AGENDA
HAILEY PLANNING & ZONING COMMISSION
Monday, July 22, 2013
Hailey City Hall
5:30 p.m.

AGENDA
HAILEY PLANNING & ZONING COMMISSION
Monday, July 8, 2013
Hailey City Hall
6:30 p.m.

PRELIM SITE PLAN

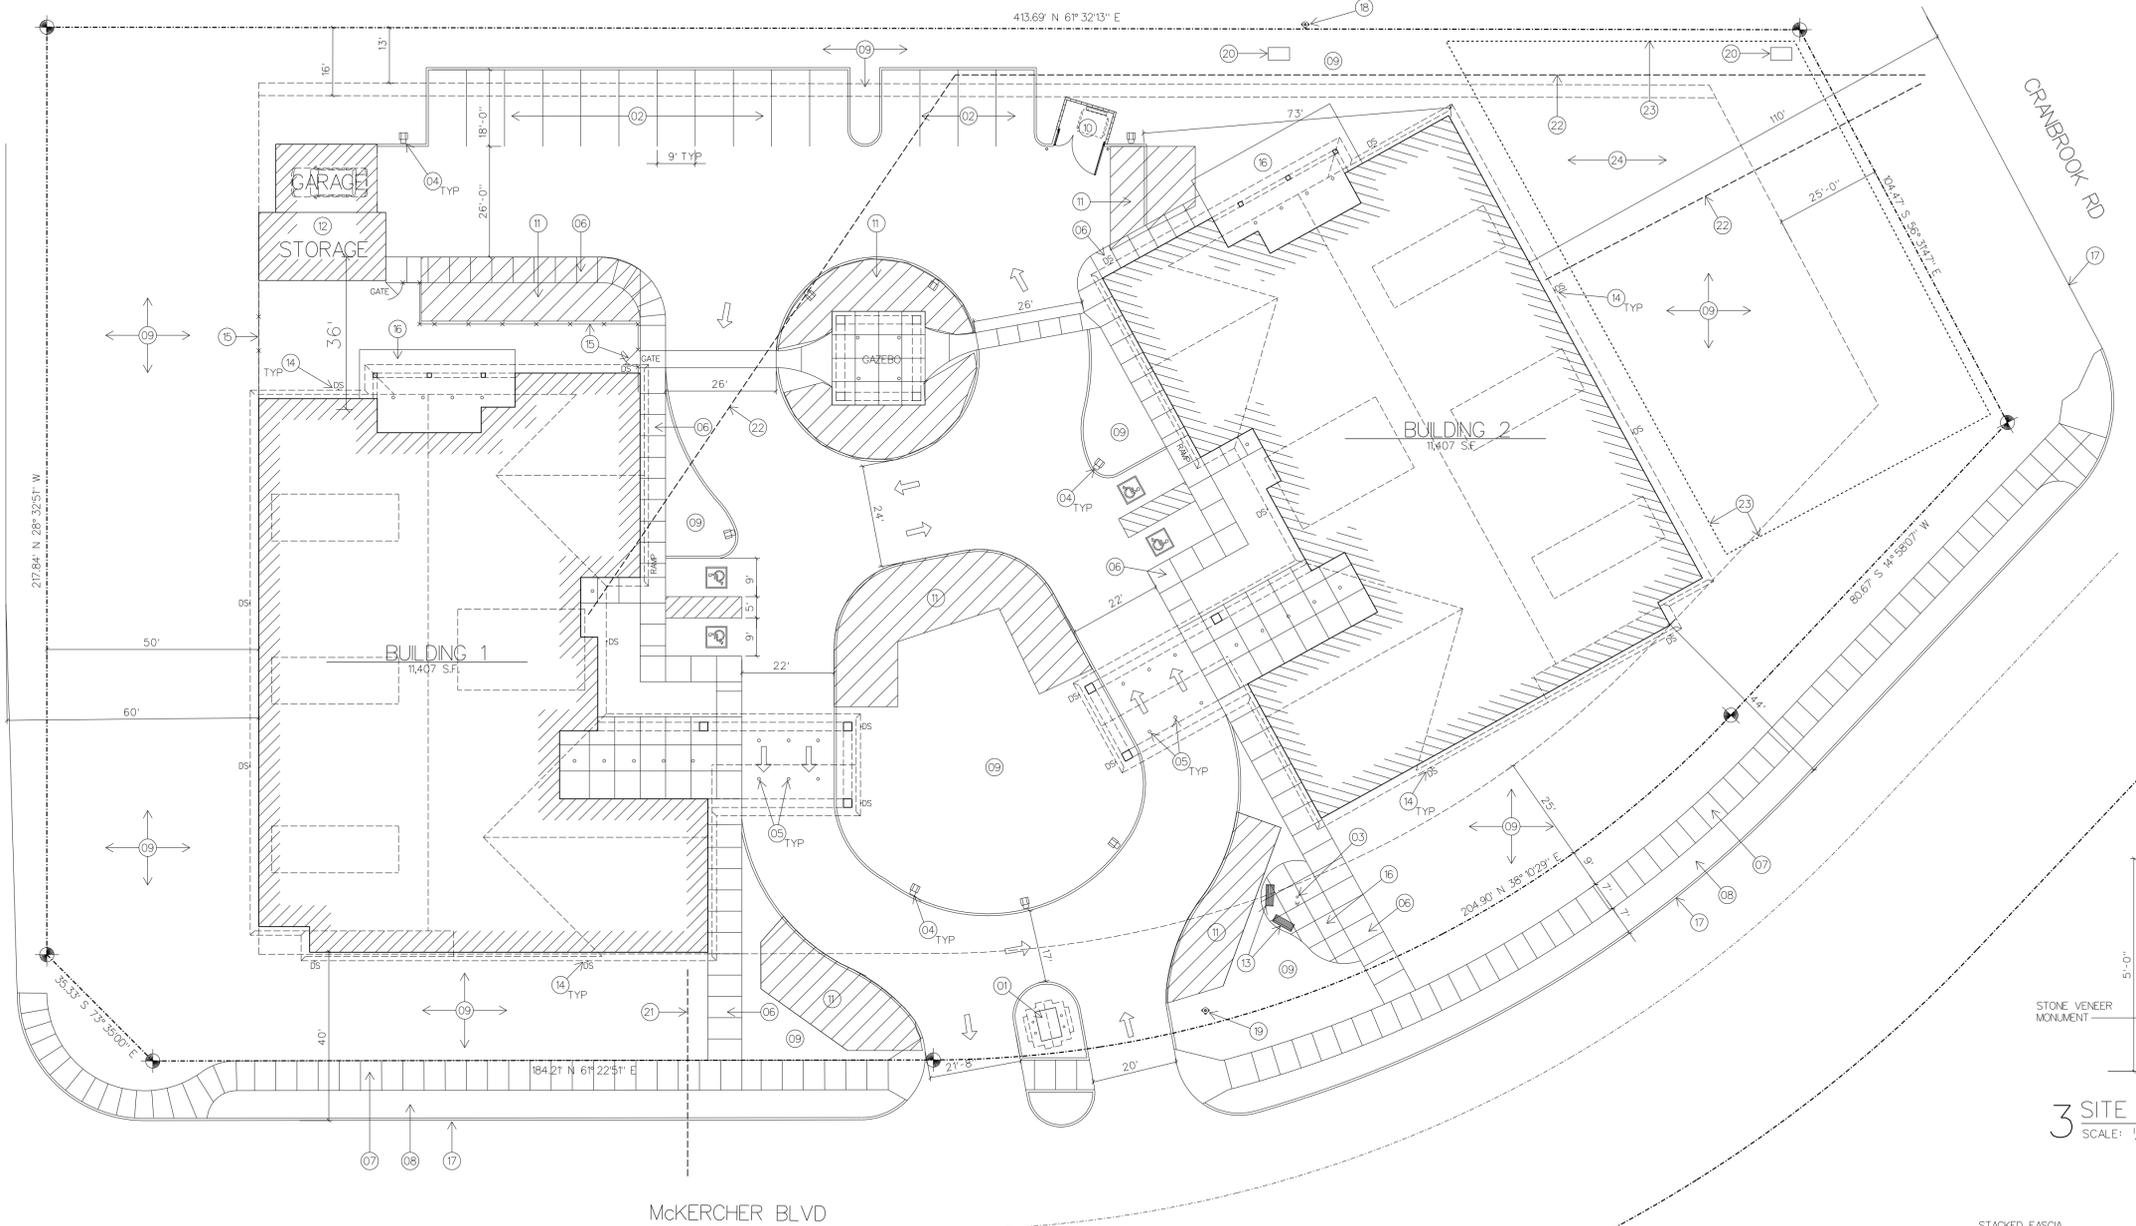
<i>Staff Comments</i>	<p><i>Site plan shows 5,150 sf for snow storage, which equates to 26% of total impervious services used for parking.</i></p> <ul style="list-style-type: none"> - <i>Total paving and concrete surfaces for parking equates to 19,942 square feet</i> - <i>5,150 square feet is dedicated to snow storage, equating to 26% of the total paving and concrete areas.</i>
<input checked="" type="checkbox"/>	<input type="checkbox"/>	<input type="checkbox"/>	6A.8(A)1j	<p>j. Snow storage areas shall not be less than 25% of the improved parking and vehicle and pedestrian circulation areas.</p>
			<i>Staff</i>	<p><i>Site plan shows 5,150 sf for snow storage, which equates to 26% of total</i></p>

<i>Comments</i>	<i>impervious services used for parking.</i> <ul style="list-style-type: none"> - Total paving and concrete surfaces for parking equates to 19,942 square feet 5,150 square feet is dedicated to snow storage, equating to 26% of the total paving and concrete areas.
<input checked="" type="checkbox"/>	<input type="checkbox"/>	<input type="checkbox"/>	6A.8(A)1k	k. A designated snow storage area shall not have any dimension less than 10 feet.
			<i>Staff Comments</i>	<i>- The current snow storage plan shows six different sites for snow storage. None of these sites have a dimension less than 10 feet.</i> <ul style="list-style-type: none"> o The smallest dimension shown is approximately 11 feet.
<input checked="" type="checkbox"/>	<input type="checkbox"/>	<input type="checkbox"/>	6A.8(A)1l	l. Hauling of snow from downtown areas is permissible where other options are not practical.

2 CLOCK TOWER ELEVATION
SCALE: 1/4" = 1'-0"

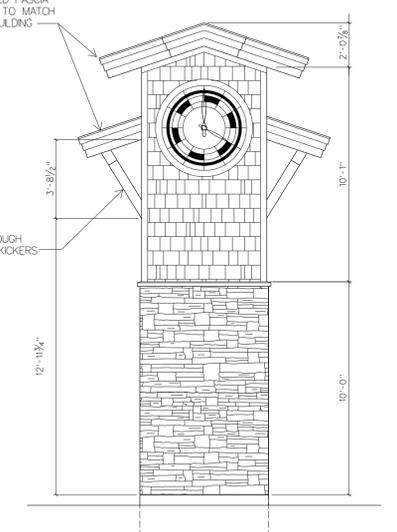
15. The clocktower and sign shall not be lit, according to Article 8.2 of the Zoning Ordinance.
16. The condensing units shall be screening with year-round landscaping to fully buffer the visual impact of the condensing units.
